Florida Department of Environmental Protection

OCD-SW-09-0326

Volusia County – SW
Tomoka Farms Road Landfill WACS #27540
Review of Evaluation Monitoring Plan and Related Documents

Attachment I: Review Comments on the Contamination Evaluation Report, and the Biennial Report (2007 - 2009)

Figure A

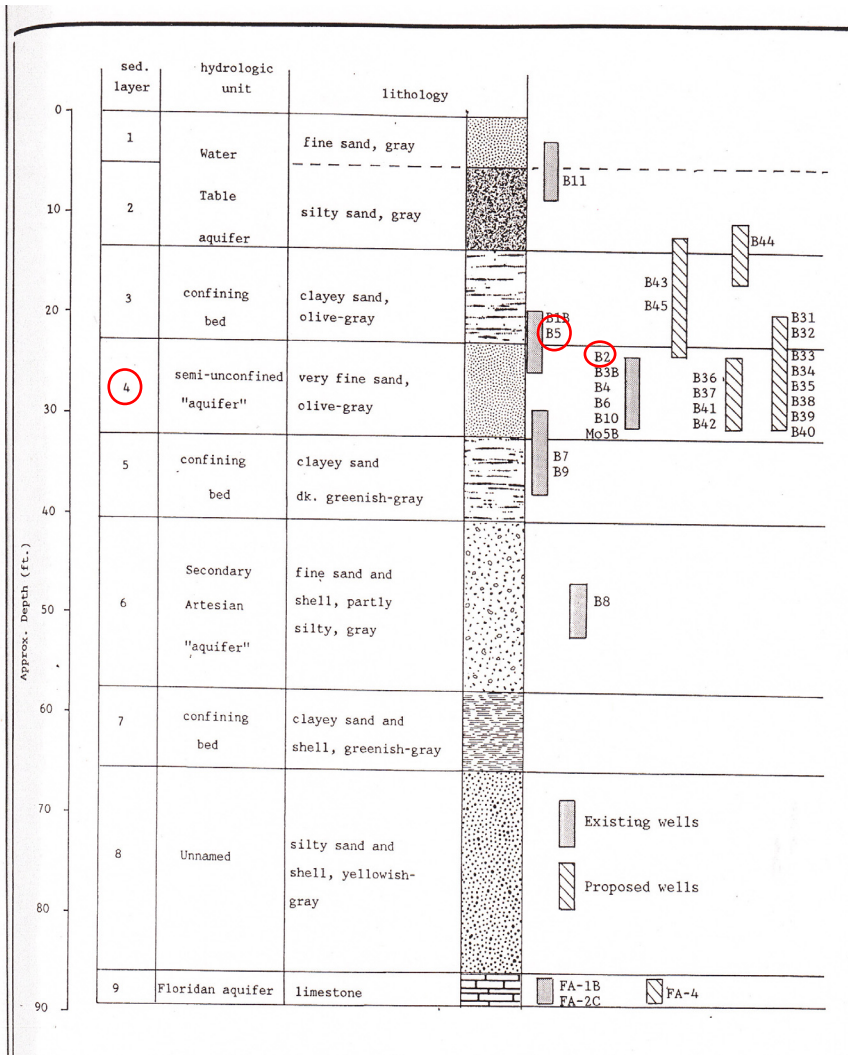
1. The Department's November 26, 2007 response to the 2007 Biennial noted that B-2 and B-5 are in Zones 4 instead of Zone 1-2. The facility's December 21, 2007 response disagreed and noted that B-2 and B-5 should have their zone designations changed to Zone 1-2. However the facility's response referenced well screen elevations. The zones are not based on screen elevations but on stratigraphic zones. (See Attachment III, Figures A and B) These differences can influence the ground water mapping. If the zones for B-2 and B-5 are to be changed in the MPIS, the response must include a discussion of the soil boring logs and why Dr. Gomborg's designations are not correct. (Note B5 Zone 4 is in parenthesis "(4)" after the Zone 1-2 listed for the MPIS.)
